Village of Arlington Heights
Plat and Subdivision Committee
Community Room, 3rd Floor
Arlington Heights Village Hall
33 S. Arlington Heights Road
Arlington Heights, IL 60005
January 13, 2016
6:30 PM

Item: Westgate Dental - 2932 W. Euclid Ave. - T1516

STAFF DEVELOPMENT COMMITTEE REPORT

To: Plat and Subdivision Committee
Prepared By: Bill Enright, Deputy Director Planning and Community Development
Meeting Date: January 13, 2016
Date Prepared: January 7, 2016
Project Title: Westgate Dental
Address: 2932 W. Euclid Ave

SITE PLAN

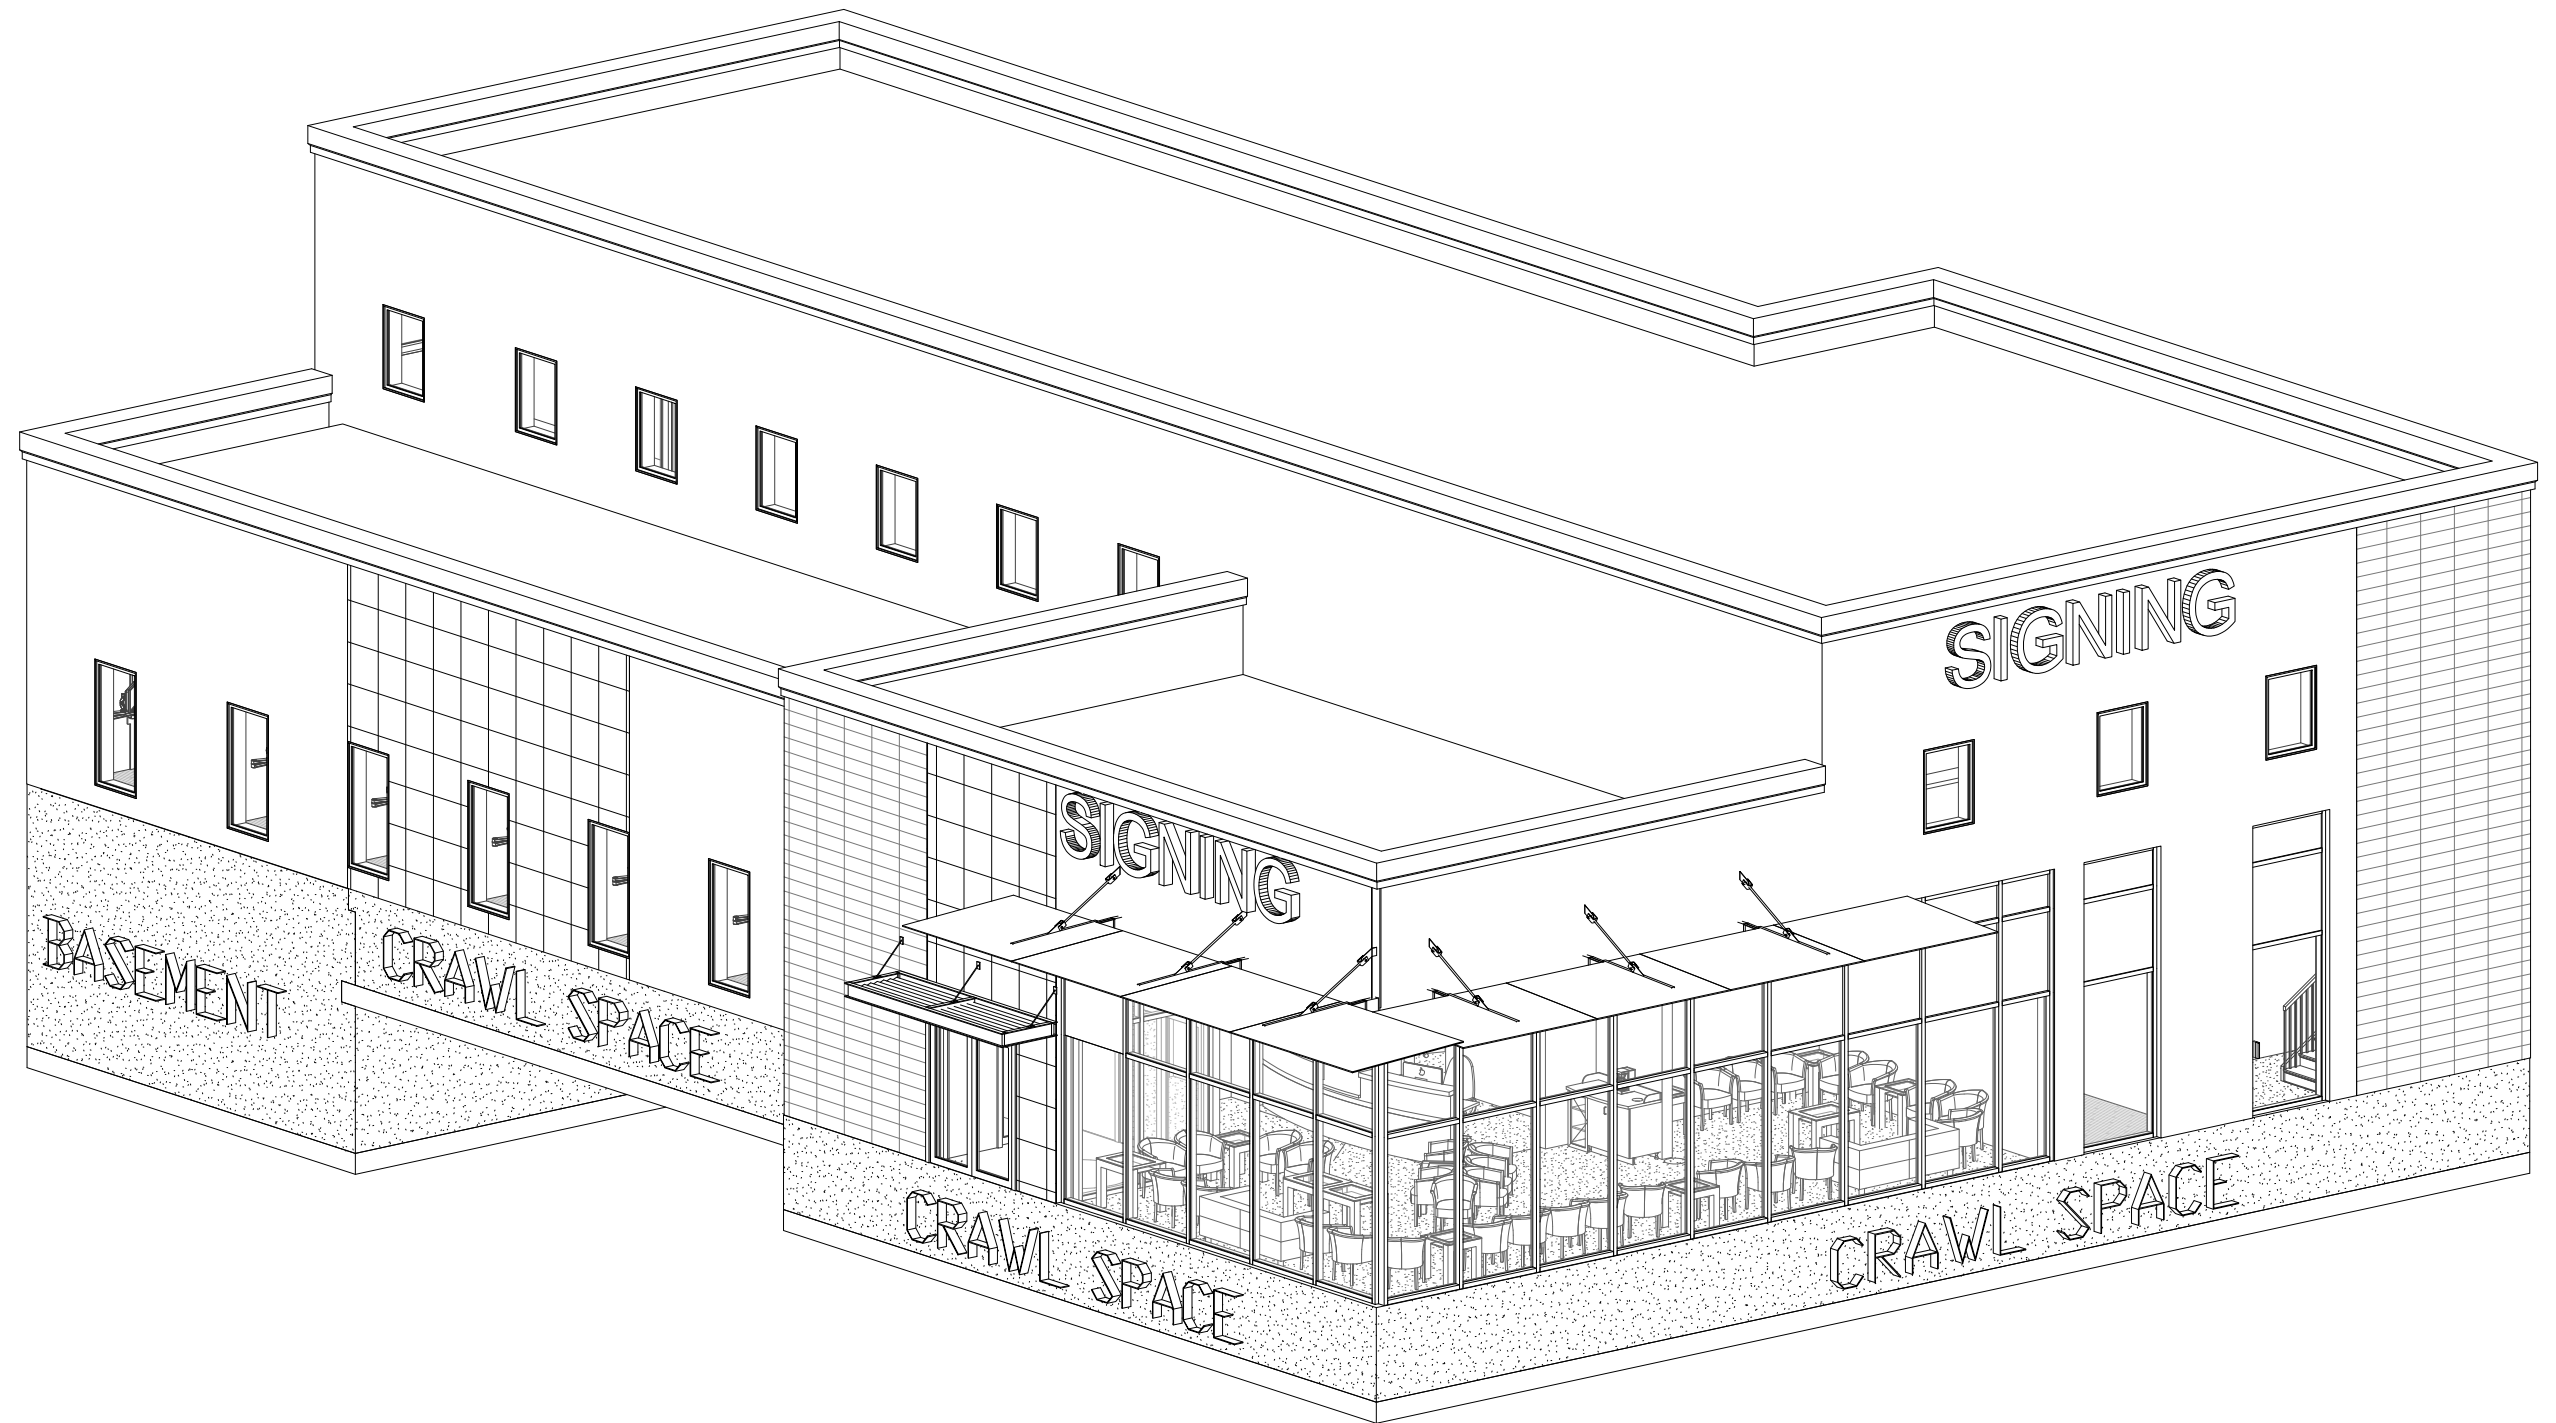
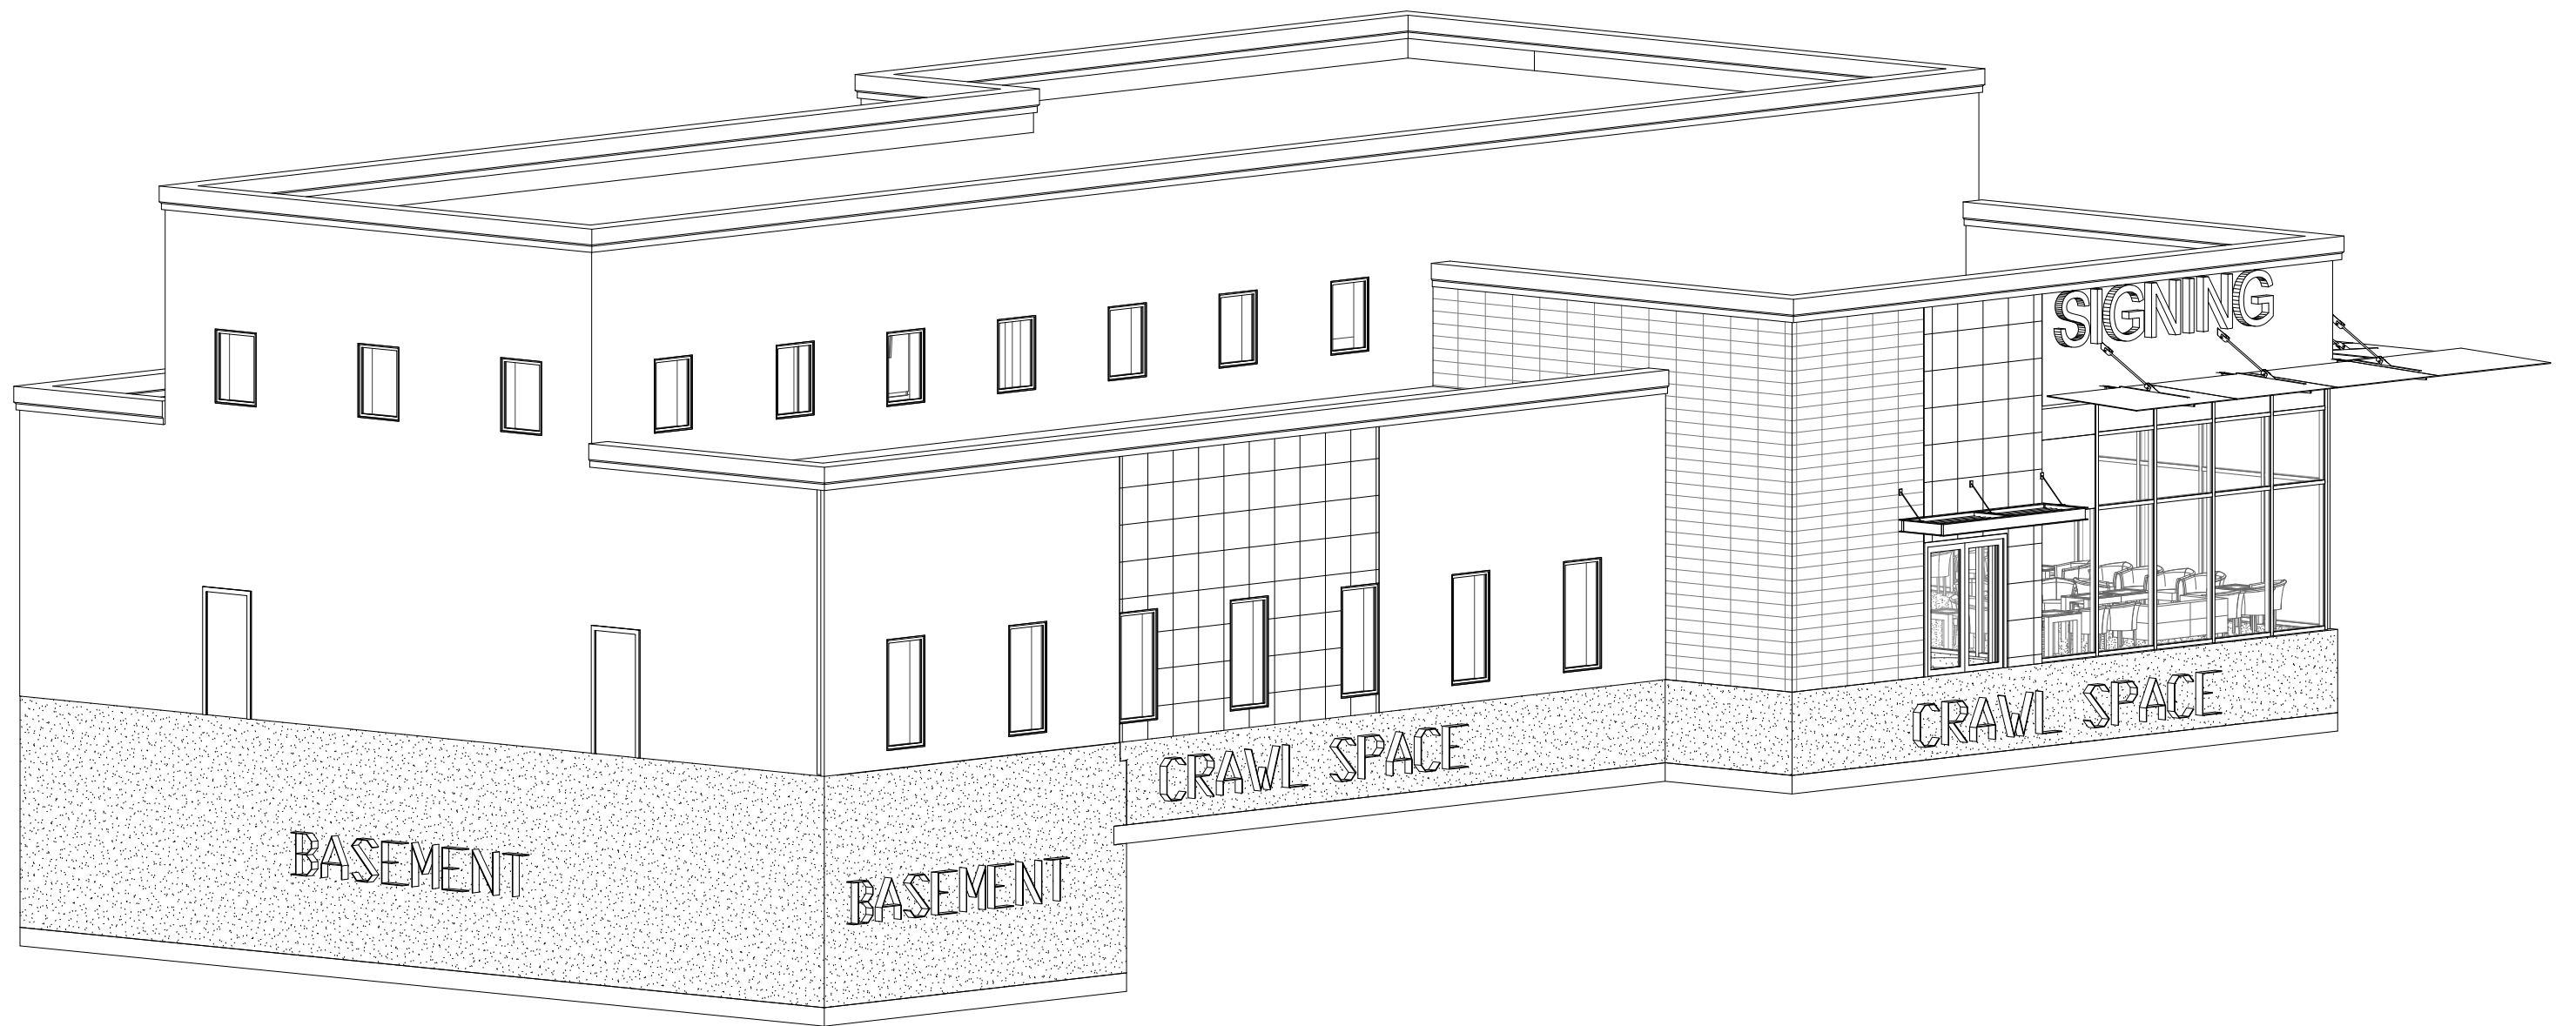
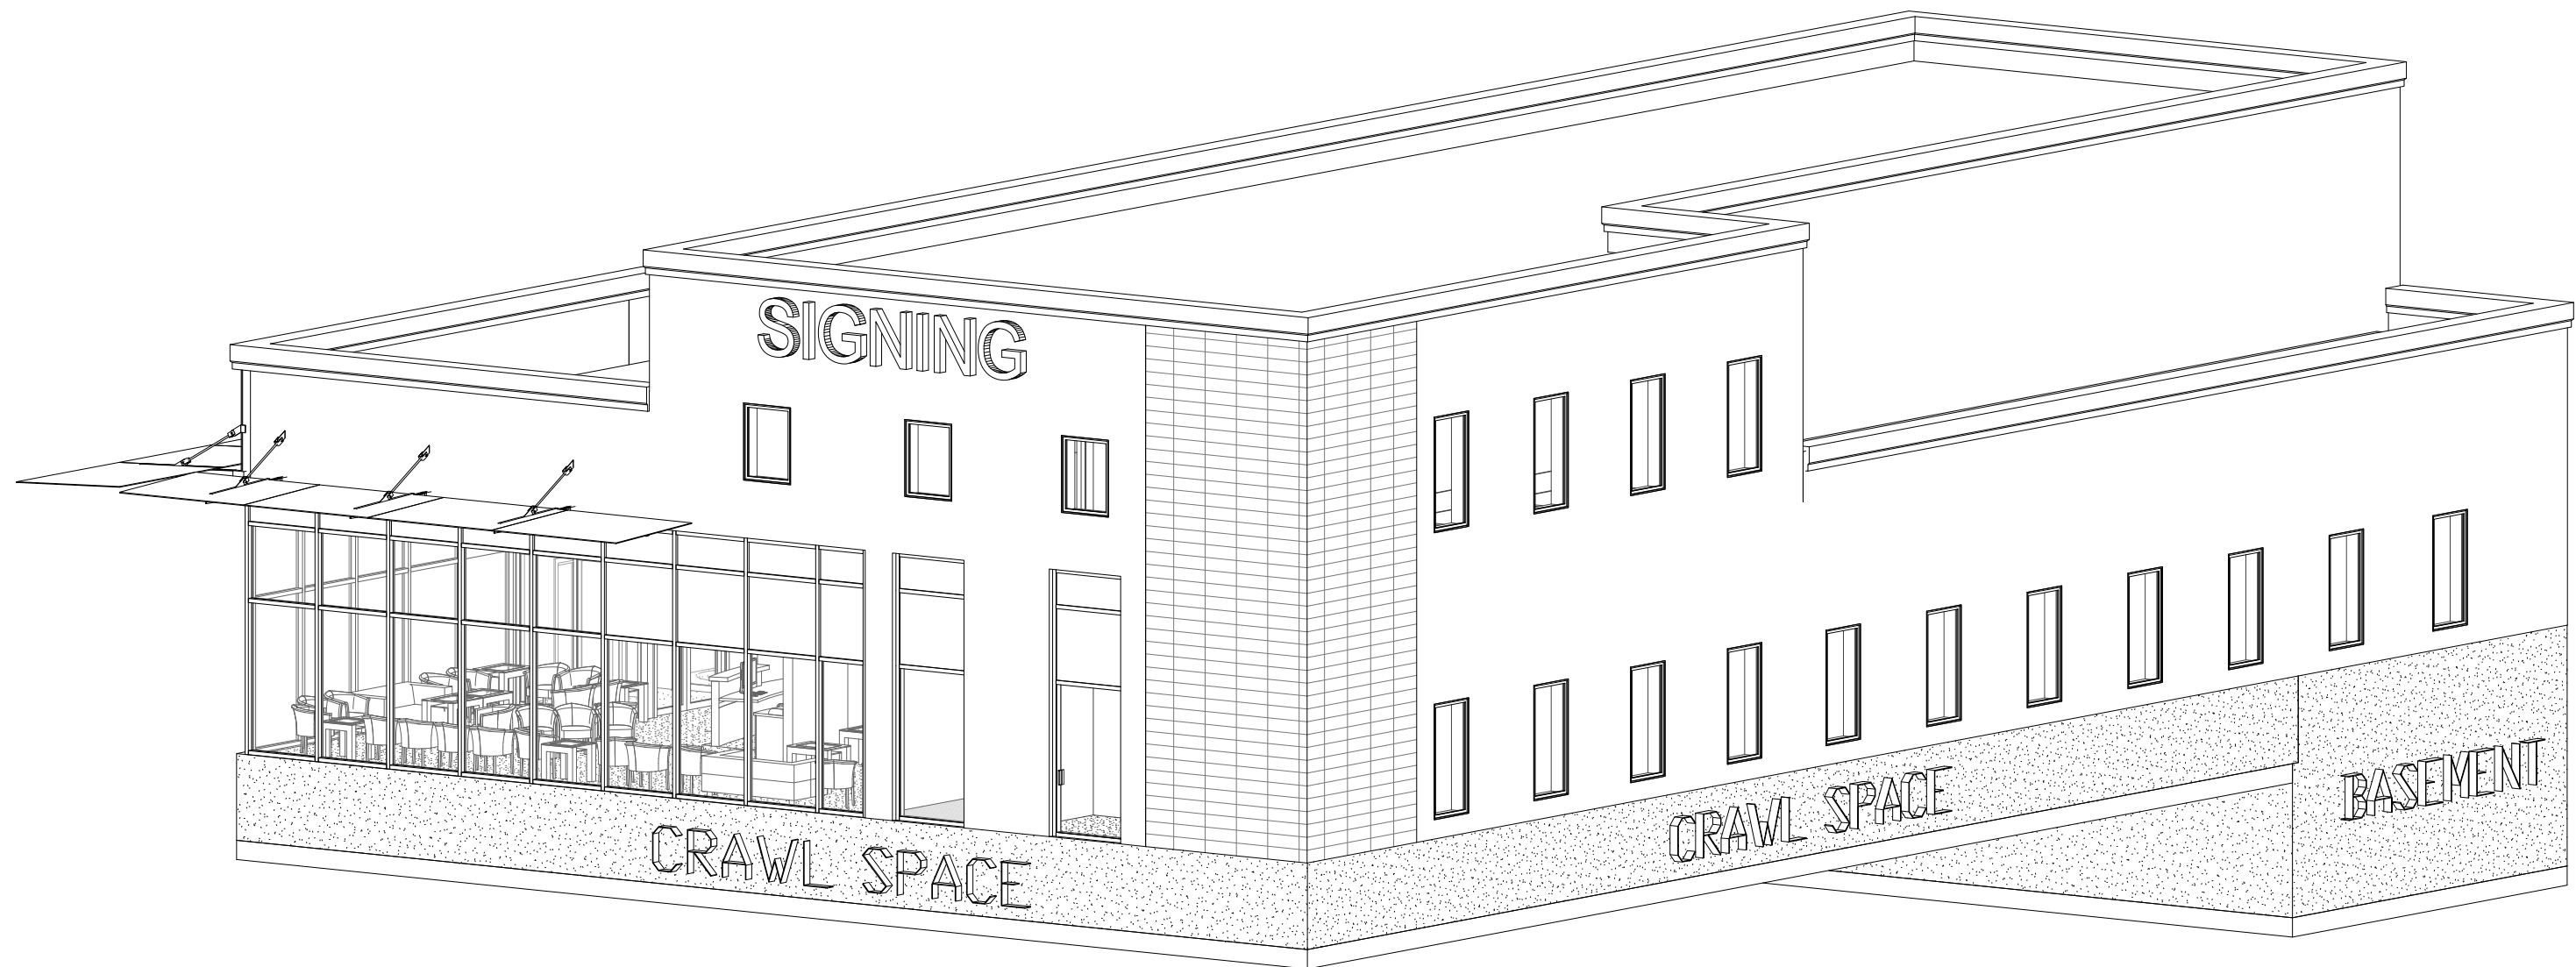
The circulation around the east portion of the site is modified with the proposal. Currently there is an unobstructed drive aisle that wraps around the vacant open space and provides access to the rear of the existing shopping center. It is presumed that this drive aisle is utilized primarily for access to the Starbucks drive through for those turning into the site from Euclid Avenue. The new site plan will replace the existing drive with a more direct circulation path but through the parking area in front of the proposed medical office building. The petitioner should consider code compliant directional signage to direct Starbucks patrons to the drive through.

The petitioner should explore a slight modification to the orientation of the 12 south parking spaces along the Euclid Ave frontage. Currently the curb line runs parallel with the angled property line which results in a drive aisle that is 29 feet wide tapering down to 24 feet. Since 24 feet is the standard, it is recommended that the south curb line is adjusted so that these parking spaces are parallel with the remainder of the parking lot. There is an underground detention vault proposed under those parking spaces so it is not known if the orientation of the parking is due to the location of the vaults.

There is currently a 15 foot wide public utility easement that runs north to south adjacent to the proposed east side of the new office building. The petitioner shall provide information as to what utilities, if any, are within this easement as the proposed building is directly adjacent to said easement. This could be an issue with building foundations so close to the easement, depending on what the easement is utilized for and the location of any utilities within that easement.

The building architecture will require Design Review. It is recommended that the design is compatible with the design of the existing shopping center in terms of style and materials. Also staff has concerns with the design of the rear portion of the building as it does not continue the more contemporary design of the front of the building. In addition the sidewalk in front of the building abuts the building therefore there is no foundation landscaping. The petitioner should provide space for foundation landscaping at the front of the building. Also 3 foot tall landscape screening is required adjacent to parking areas, therefore the parking spaces fronting Euclid shall include the required screening. The end of all rows of parking shall include the required shade trees.

Storm water detention is required. The petitioner intends to provide detention in an underground vault at the south end of the property under the parking area. Since there are utilities that service the existing center that cross the parking areas of the new office building, easement agreements for these utilities will be required, including maintenance agreements if any utilities are shared.

1. The Petitioner shall provide information on the use of the existing 15 foot public utility easement to the east of the proposed office building including the location of any existing utilities within said easement.

2. The existing sidewalk along Salt Creek Lane should be extended to Euclid Avenue to link up with the proposed bike path.
3. The Petitioner shall provide parking counts conducted over a three day period for two weeks to demonstrate that the site has sufficient parking for the existing and future uses.

4. Cross access easement agreements shall be provided.
5. Easement agreements for private utilities shall be provided as necessary.
6. Design Review shall be required. The petitioner should design the office building to compliment the existing shopping center in terms of design style and materials used.

7. Landscaping at the base of the building should be incorporated into the site design. Also 3 foot tall screening of parking areas is required as well as shade trees at the end of each parking row.
